LiDAR Quality Assessment Report

Project ID:
MO_NewMadrid-DOGAMI_2012

Project Alias(es):
New Madrid Mo.

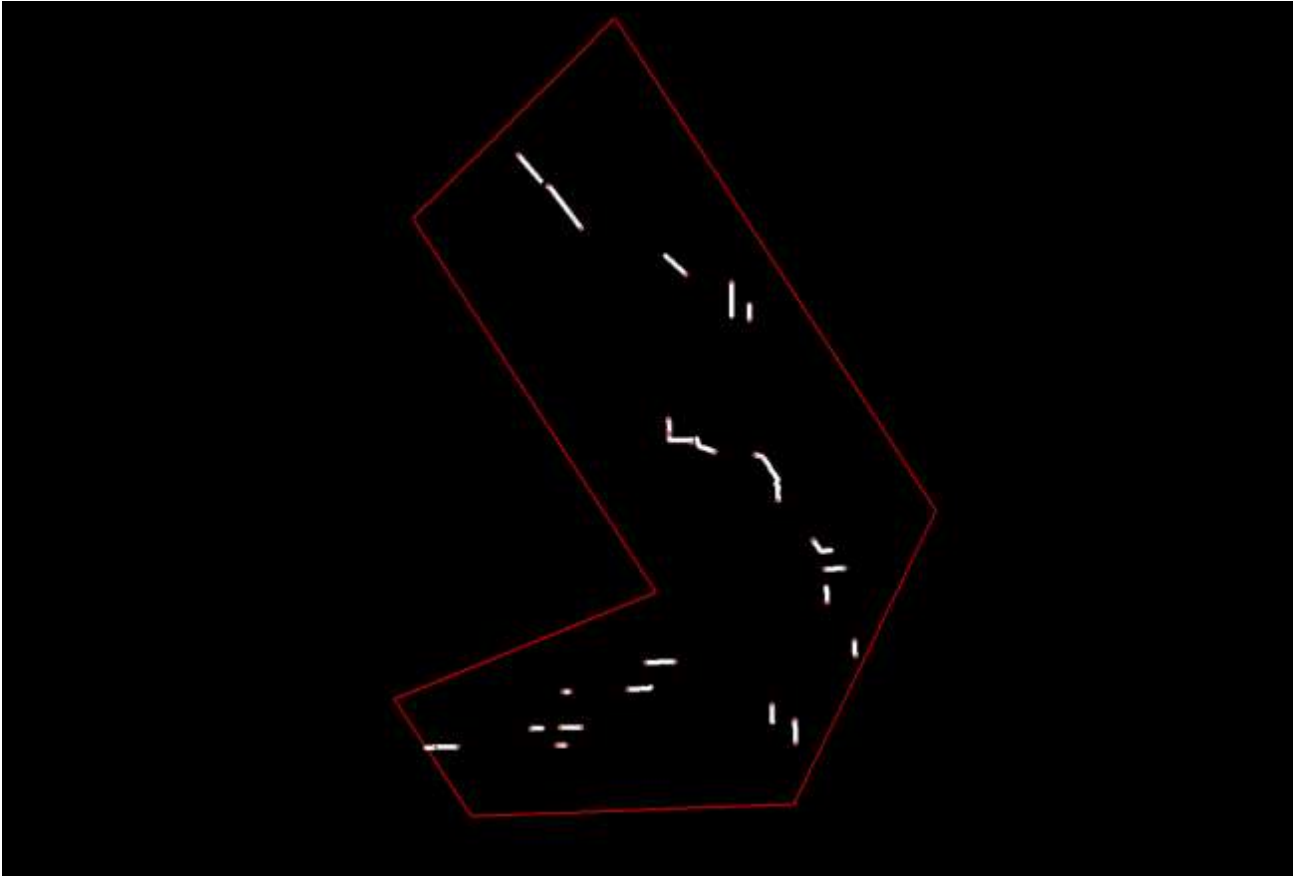
Points are not randomly distributed throughout the dataset. All points have been collected as hard surface and appear to have all been collected on the shoulder of paved roads and or highways.

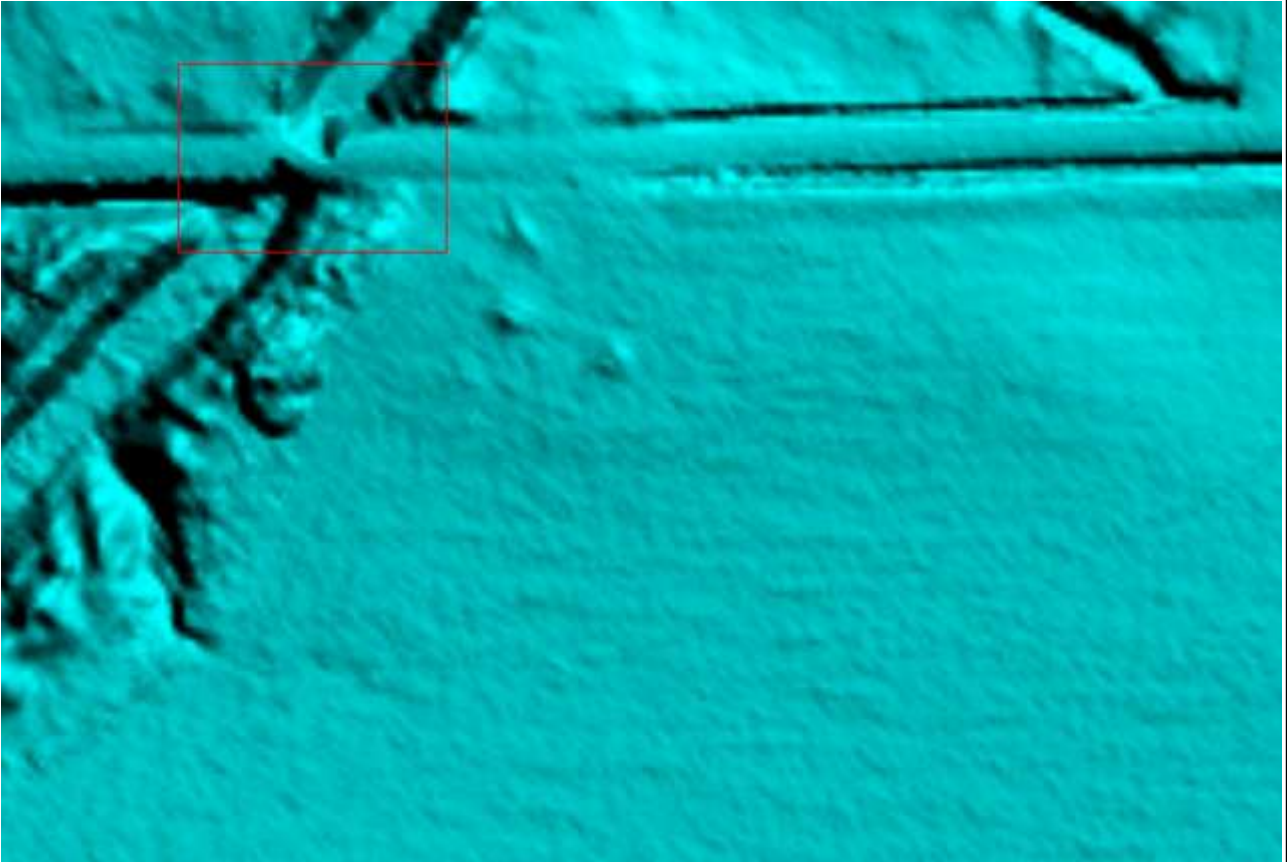
one culvert was found partially removed. culverts are not required to be removed.
culvert location 36° 30' 55.9113" N, 90° 14' 29.1895" W
